SERVICE BULLETIN

Transmission
& Clutch
REFERENCE _____
NUMBER 013
DATE 08-12-88
MODEL AE, FX-16, AW

A240# AUTOMATIC TRANSAXLE INTERCHANGEABILITY

This Service Bulletin has been prepared to assist you in identifying the three types (D, E, & F) of A240# automatic transaxle/cases used.

(D) Type ⊙: threaded boss

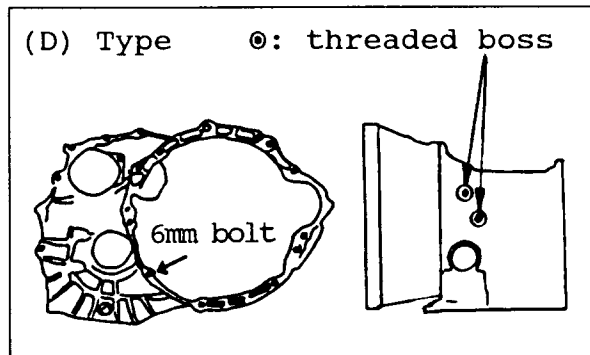
- The different designs of the automatic transaxle cases used are classified as "D", "E", or "F" type.
- The shape, production range, part number and interchangeability are as follows:
